This letter is to inform the co-lead agencies of PolyMet's plan to adjust engineering controls for the stream augmentation system for the NorthMet Project. None of the adjustments detailed below are new controls for the Project; in other words, all of the impacts for these controls have been previously evaluated.

Large Figure 31  
PLANT SITE LONG-TERM CLOSURE  
NorthMet Project  
Poly Met Mining Inc.  
Hoyt Lakes, MN

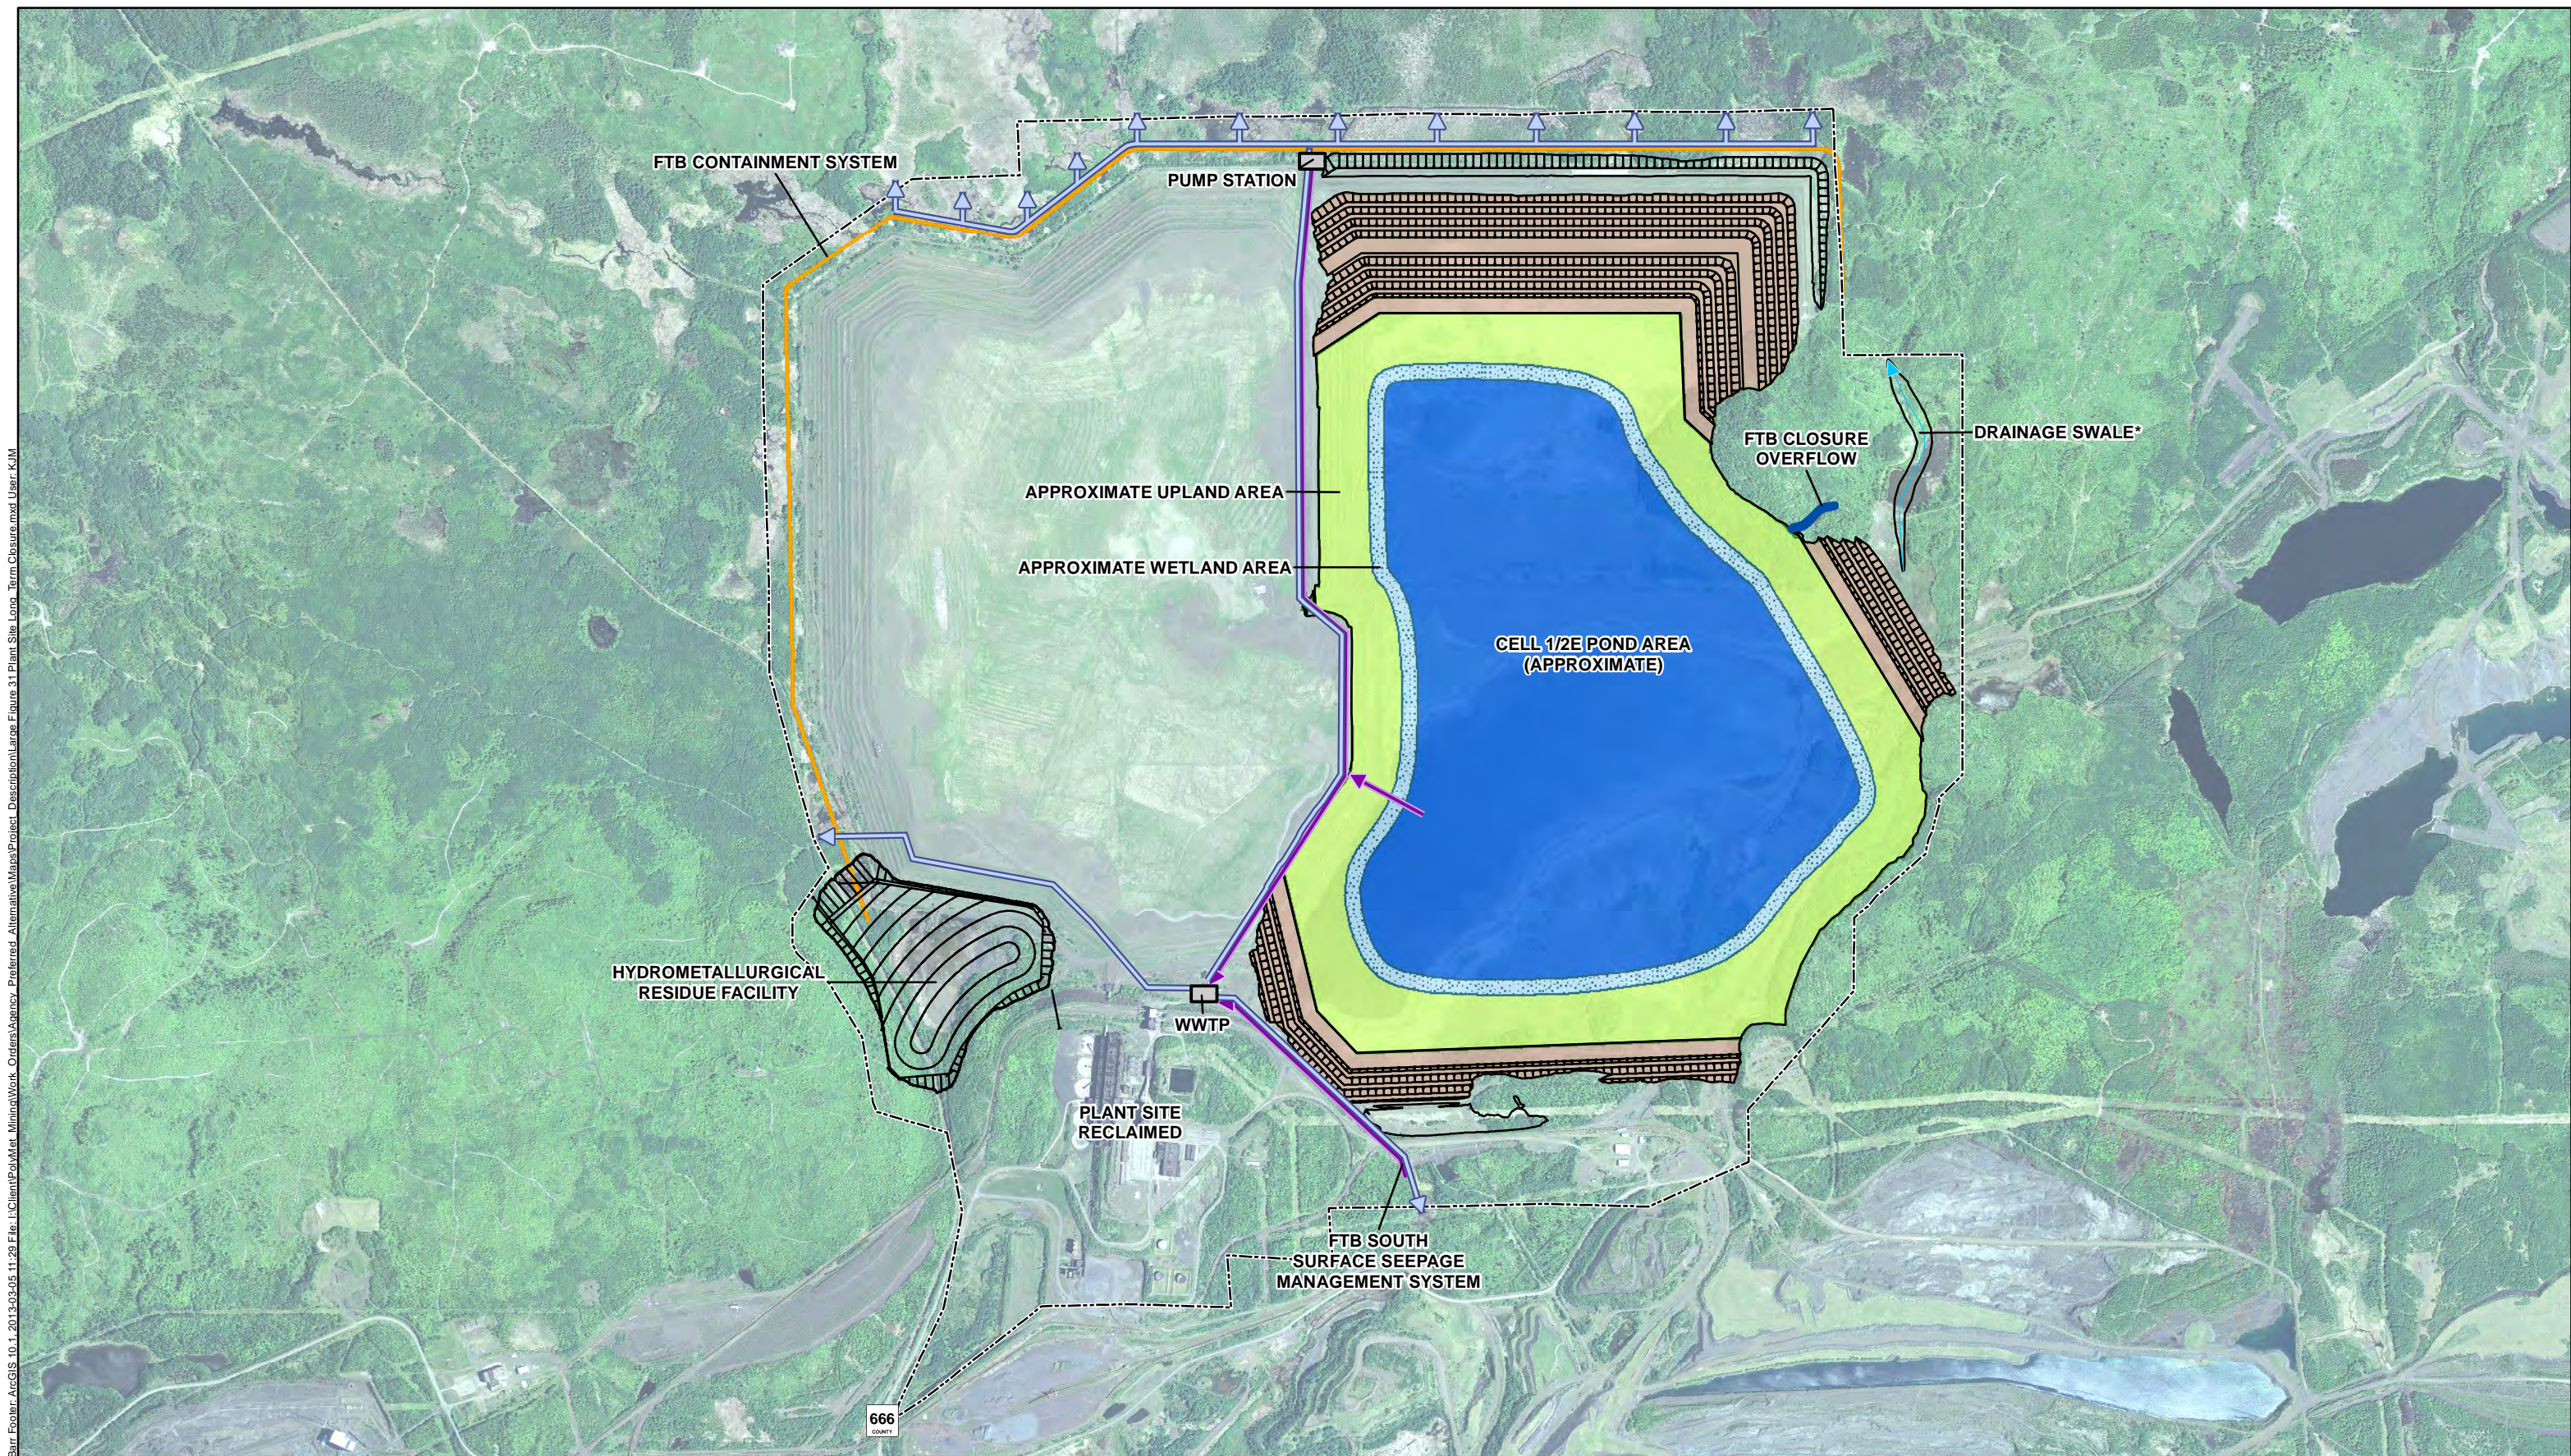
- 1) FTB WWTP: The FTB WWTP will operate at a higher average annual rate in order to provide the necessary volume of water for stream augmentation. This will not require a larger plant than was previously proposed.
- 2) Drainage Swale: The drainage swale previously proposed to be constructed concurrent with the East Dam will instead be constructed concurrent with the FTB Seepage Containment System. This is strictly a timing adjustment. This change will provide additional water to the tributaries downstream of the Tailings Basin at the beginning of operations, reducing the need for stream augmentation water from other sources. The design and function of the swale have not changed.
- 3) West Pit Flooding: The flow from the FTB WWTP discharge water used for filling the West Pit in reclamation will be reduced. The reclamation plan presented in the SDEIS

The main features of the adjustments to these engineering controls have been previously been discussed with the Minnesota Department of Natural Resources (MDNR) and the Minnesota Pollution Control Agency (MPCA). The engineering control features discussed here are the drainage swale, the FTB WWTP, stream augmentation water, and water used for filling the West Pit in reclamation. All of these features are shown in the attached map.
